TOWNSHIP OF FRANKLIN
Board of Adjustment
Agenda
Thursday, October 1, 2026

ISLAMIC CIRCLE of NORTH AMERICA / ZBA-25-00024

Re: Islamic Circle of North America, NJ, Inc. – D(1) Variance/ Site Plan (ZBA-25-00034)¹
1320 Hamilton Street; Block 90 Lot 3

Re: Tawheed Dahwah Center – Amended Preliminary and Final Site Plan + Relief of Condition (ZBA-24-00017)¹
630 South Middlebush Road (B 37.02,0 Lot 46.03)

2. Required Parking/ Variance. Below is the calculation of required parking per the Township ordinance.⁴

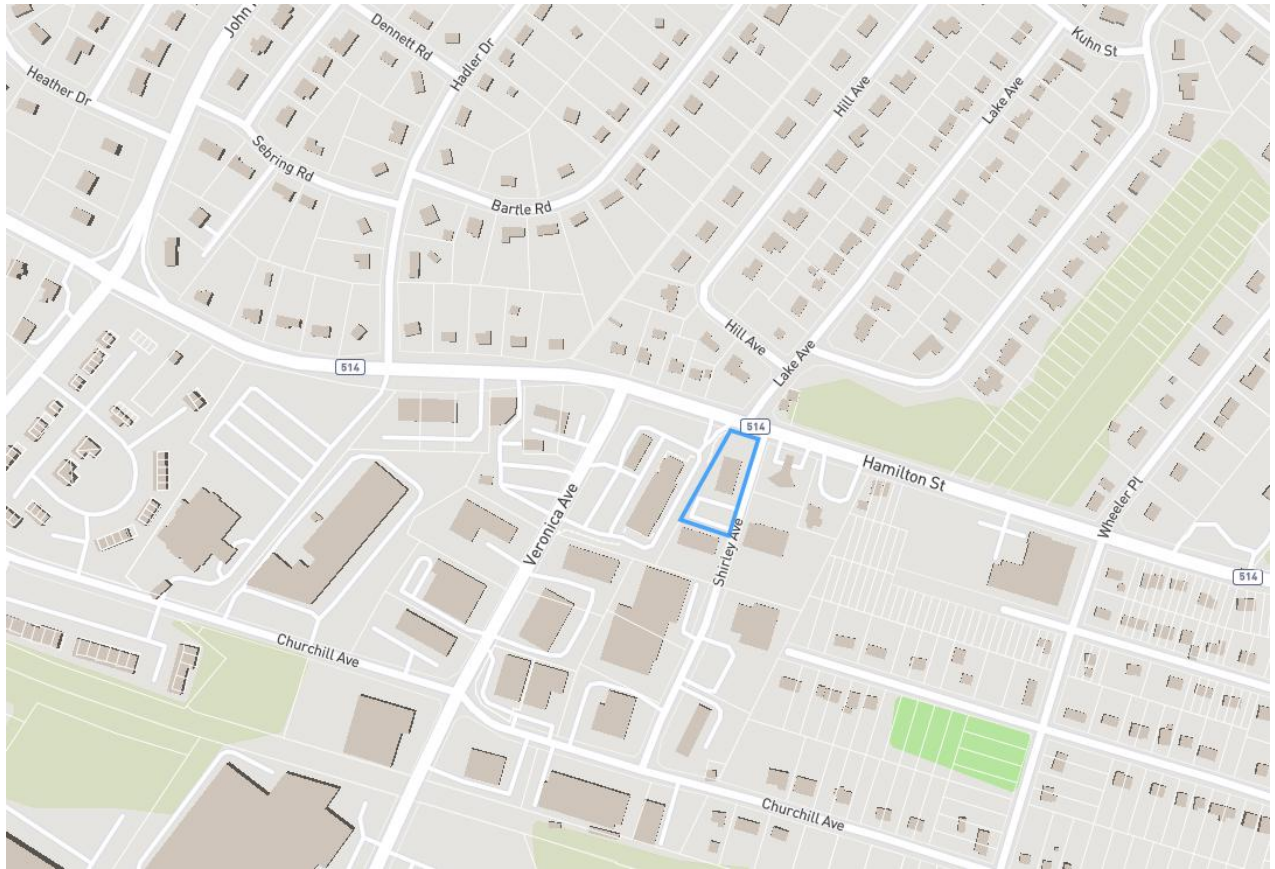
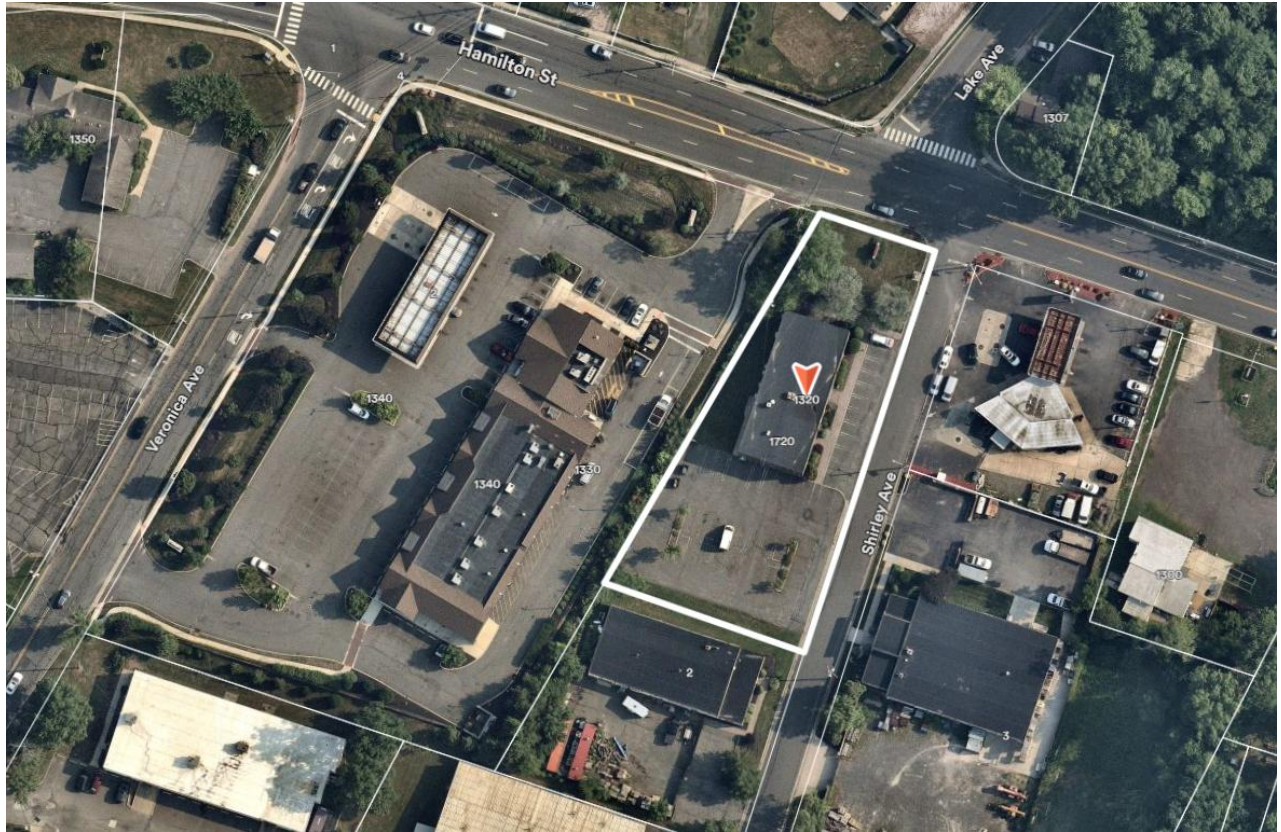
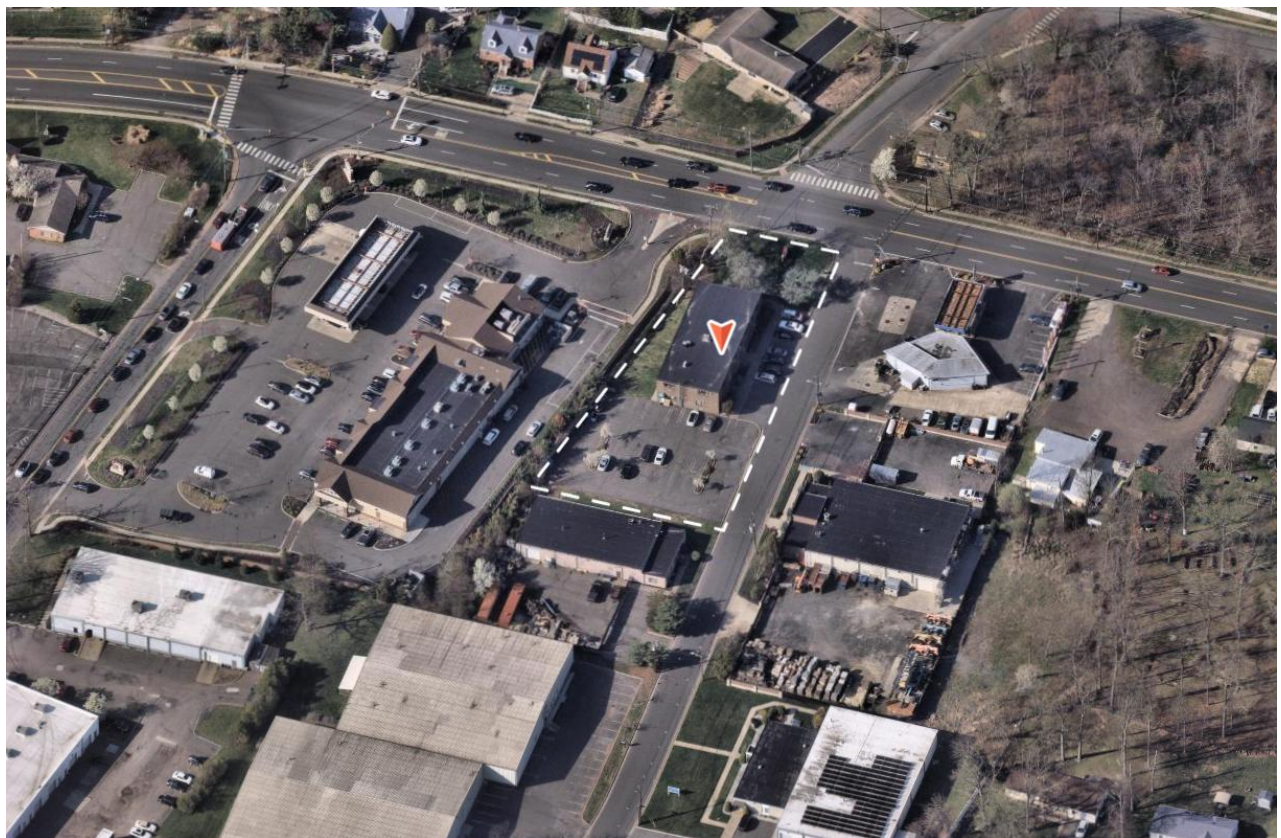
A parking variance is required (42 proposed – 47 required).

⁴ The calculations in the application contain a number of inconsistencies with respect to the square footage figures and don't follow the calculation of required parking per the ordinance (including what constitutes "net floor area"). The calculations in this report are based on: (1) calculation of required parking for the office components based on the definition of "net floor area" per the ordinance (85% of gross floor area) subtracting out the 502 square feet of the worship area; and (2) calculates the parking requirement of the worship area based on the 49-person occupancy figure cited on the plan – however this figure needs to be confirmed by the applicant as the parking requirement is based on occupancy per applicable building code. The architectural and site plans shall be revised to reflect the calculations in this report.
